4	Landscape Addendum 1	MGN	26JUN17
3	Issued for Tender	MGN	26MAY29
2	Issued for Permit	MGN	26MAY29
1	REV'd FOR COMMENT	MGN	26JAN16

Title:
LANDSCAPE PLAN

Project:
ONTARIO ABORIGINAL HOUSING SERVICES
321 JOHN STREET
COBOURG, ON

LANDSCAPE DETAILS

Drawing No: L5

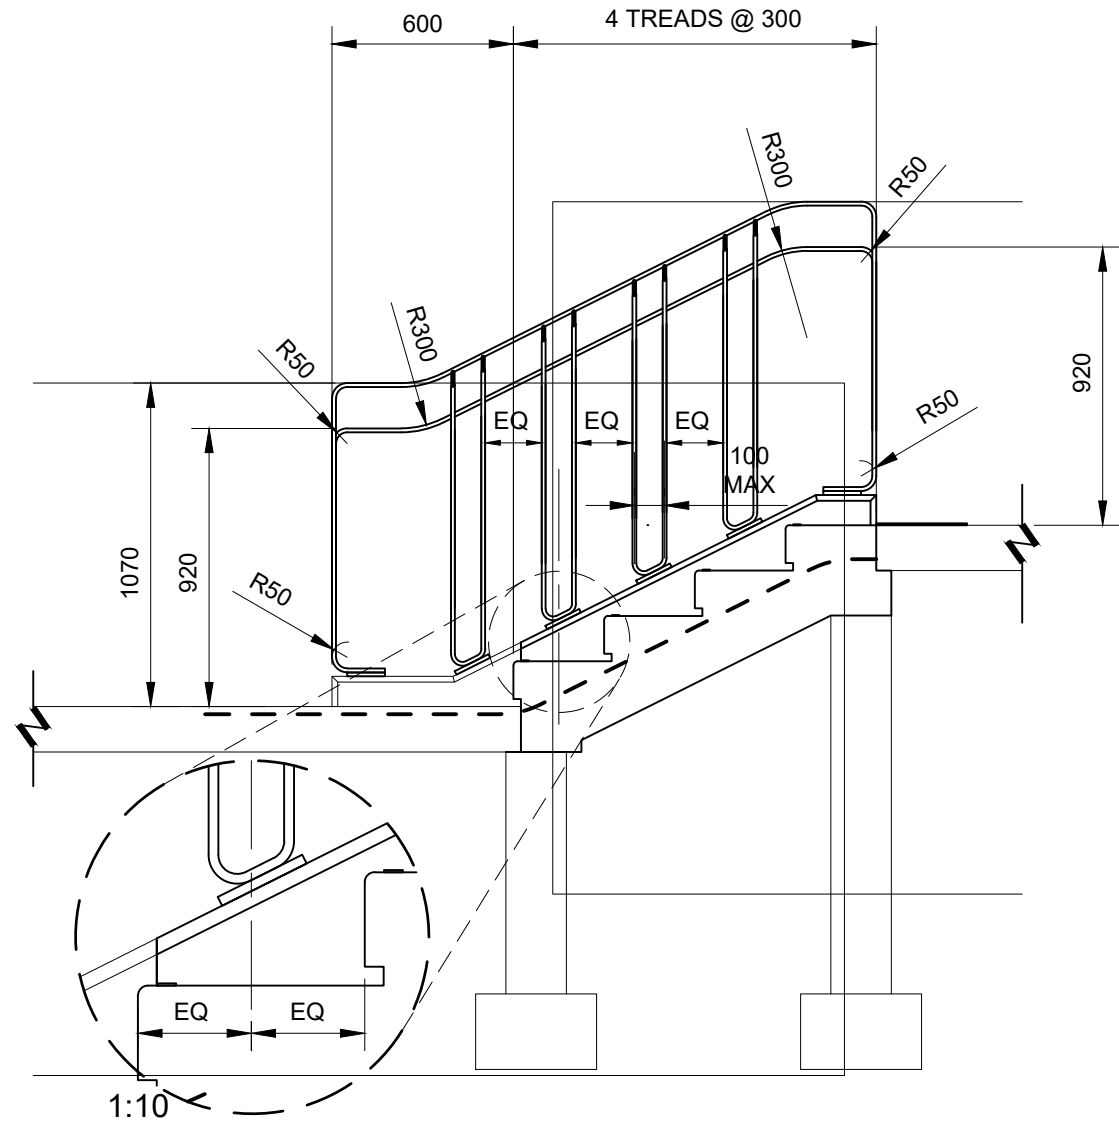
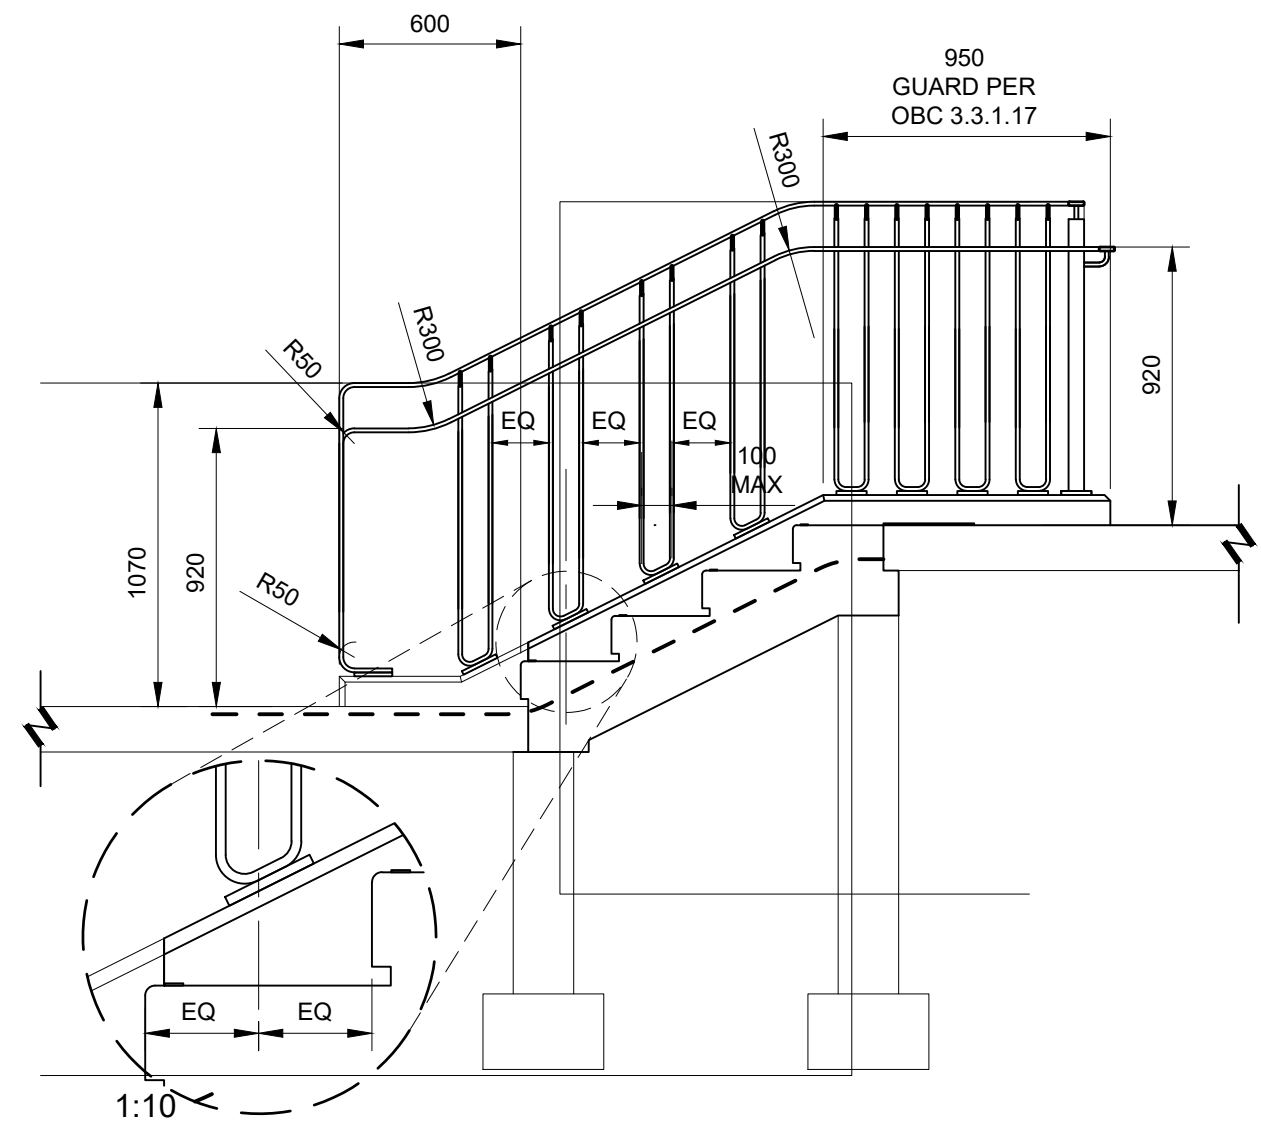
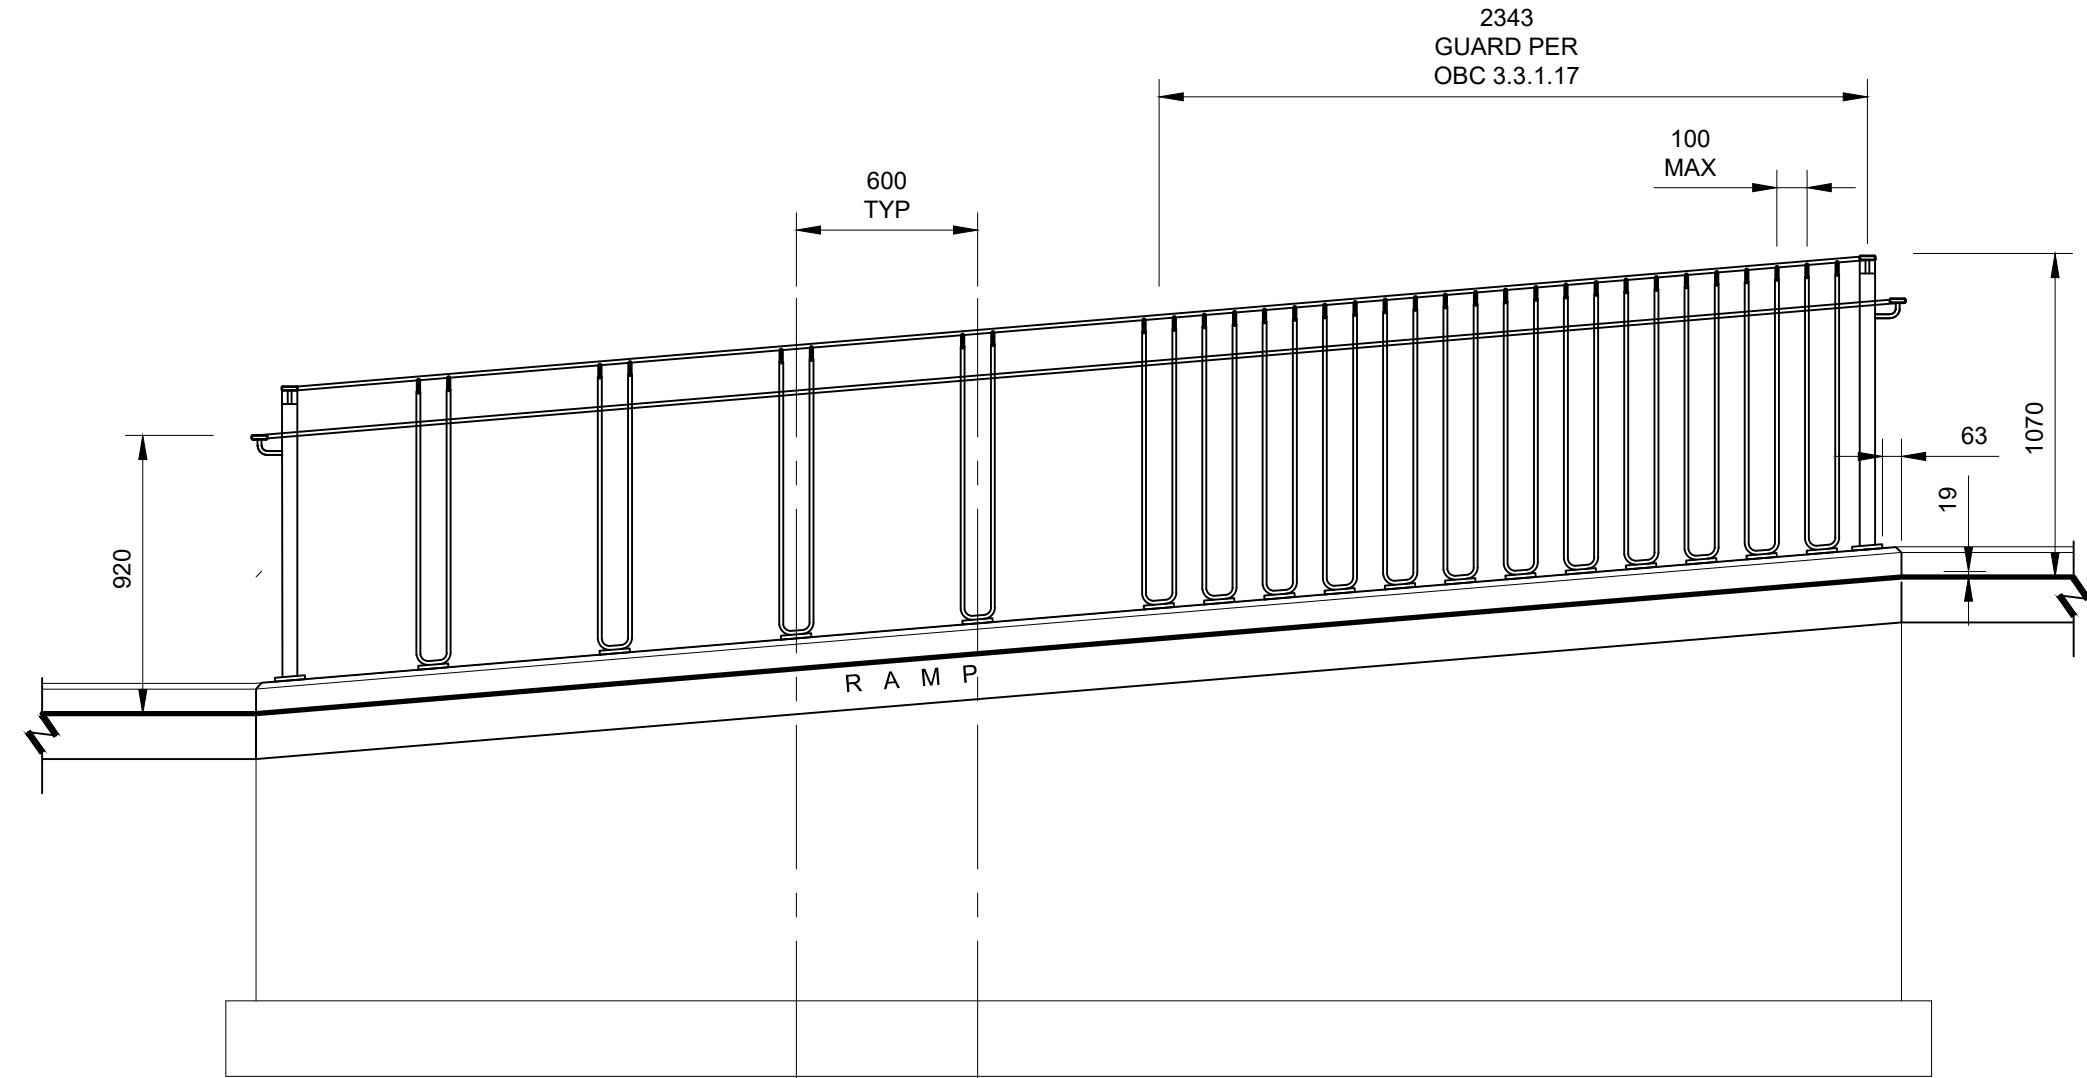
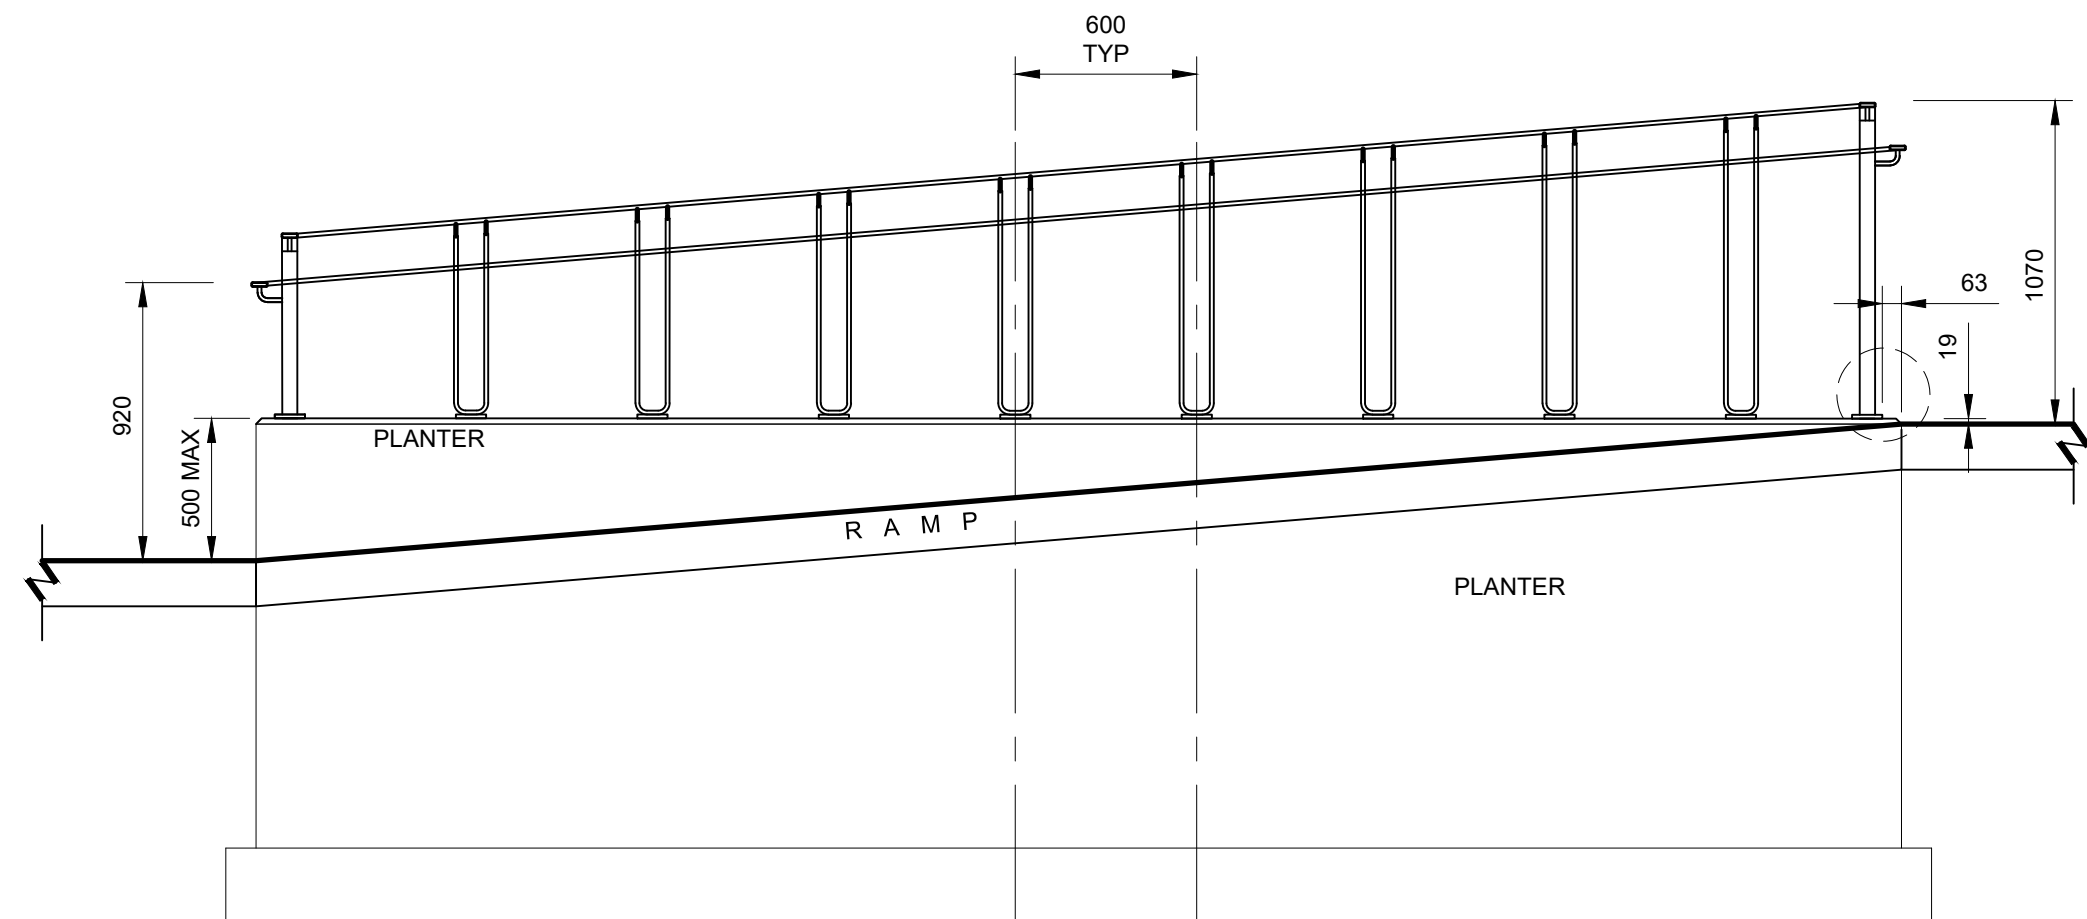
ALL DETAILS THIS SHEET:
Submit shop drawings, design calculations, and sealed drawings prepared by a Professional Engineer licensed in the Province of Ontario for review prior to fabrication. Shop drawings shall include all dimensions, materials, connections, anchorage, finishes, and installation requirements.
